Work Order ID 157962

Item Name: Aft Crosstube - High

DART AEROSPACE LTD		Work Order:	157962
Description: Crosstube High Aft (205/212)		Part Number:	D212-664-201
Inspection Dwg: D212-664-241 Rev: E		Page 1 of 1

CHANGE:

FIGURE 1: SUPPORT INSTALLATION

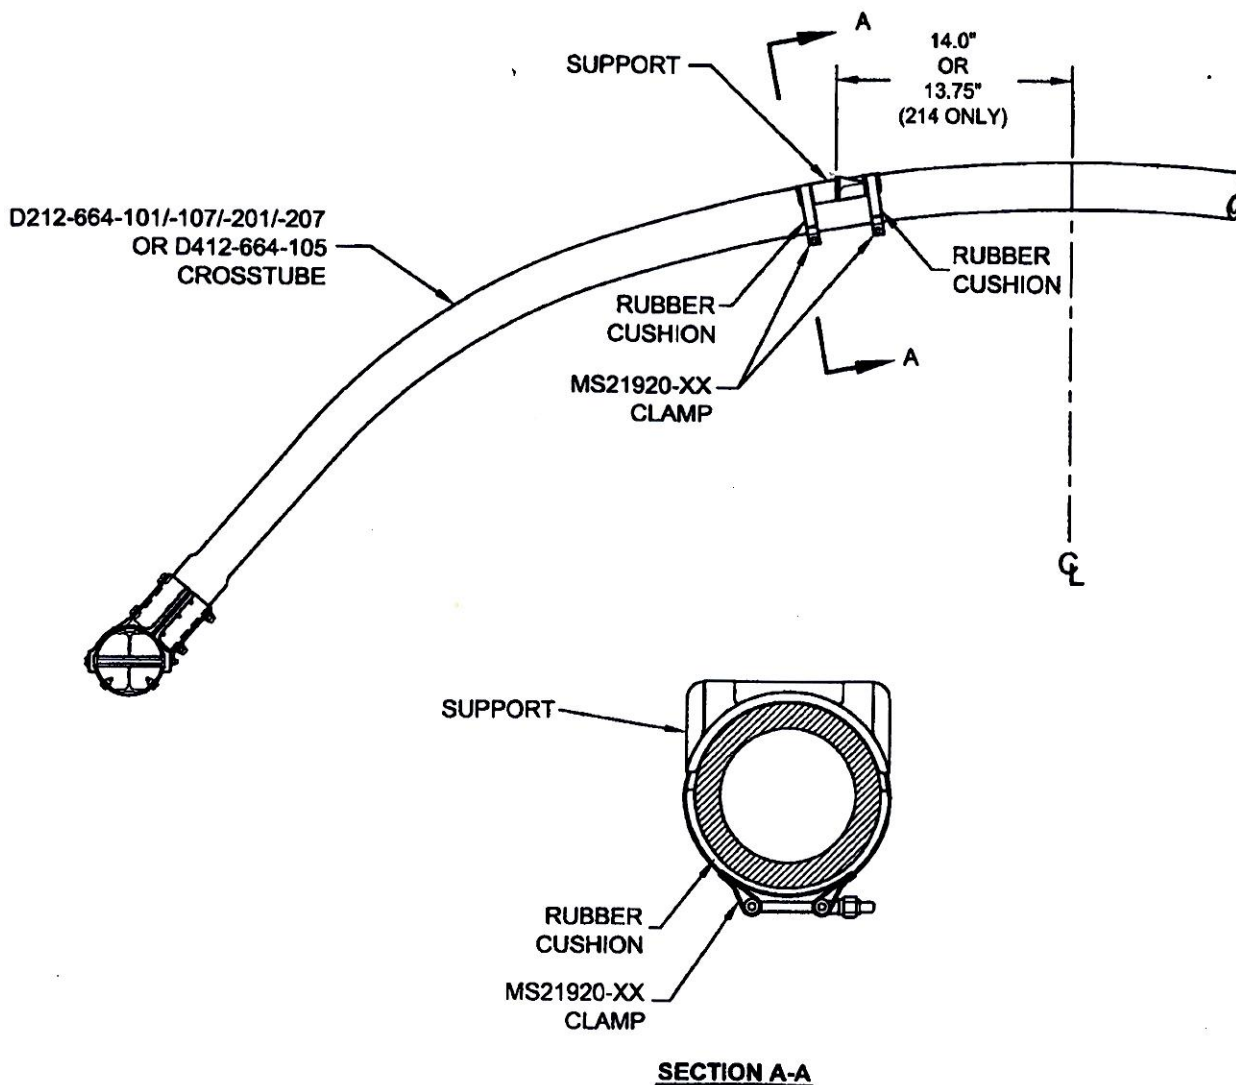
For the crosstubes listed above, section 32.4 of ICA-D212-664 is amended as follows. Use Figure 1 of this service instruction and Figures 32-2 to 32-9 of ICA-D212-664 for further reference. For crosstubes of an earlier change number, it is recommended that if the supports are removed, the supports should be reinstalled using the procedure listed below.

- 32.4.1 Locate the area on the crosstube for installation of support (see Figure 1 of this service instruction). For D212-664-101/-107/-201/-207 and D412-664-105 crosstubes, the outward face of the support tabs should be 14.0" (355mm) from the crosstube center for 204/205/210/412/UH-1 aircraft. For installation on 214B/B-1 aircraft, the outward face of the support tabs should be 13.75" (349mm). Ensure paint finish of crosstube is intact; touch up as required per Chapter 5 (5.3.9) of ICA-D212-664.

- 32.4.2 If present, remove any paint/primer on bottom of supports. Abrade mating surfaces of support and crosstube with 400-grit sandpaper. Saturate a clean cloth with MEK or 4105S Wash'n'Wipe Degreaser or equivalent and wipe until there is no residue.

- 32.4.5 Apply a 0.04" to 0.07" thick layer of Proseal 890 Class B or AMS-S-8802 Class B sealant underneath applicable support and install support as shown in Figure 1 of this service instruction.

- 32.4.6 Install the clamps opposite to crosstube support as shown in section A-A of Figure 1. Install rubber cushions underneath each clamp around the bottom circumference of the crosstube up to the crosstube centerline. Torque clamps 80-100 in·lb (9.0-11.3 Nm). It is acceptable to use smaller or larger sized MS21920-XX clamps than those listed in ICA-D212-664, ensure that after torquing the clamps per this instruction, the nuts are in safety but not bottomed out
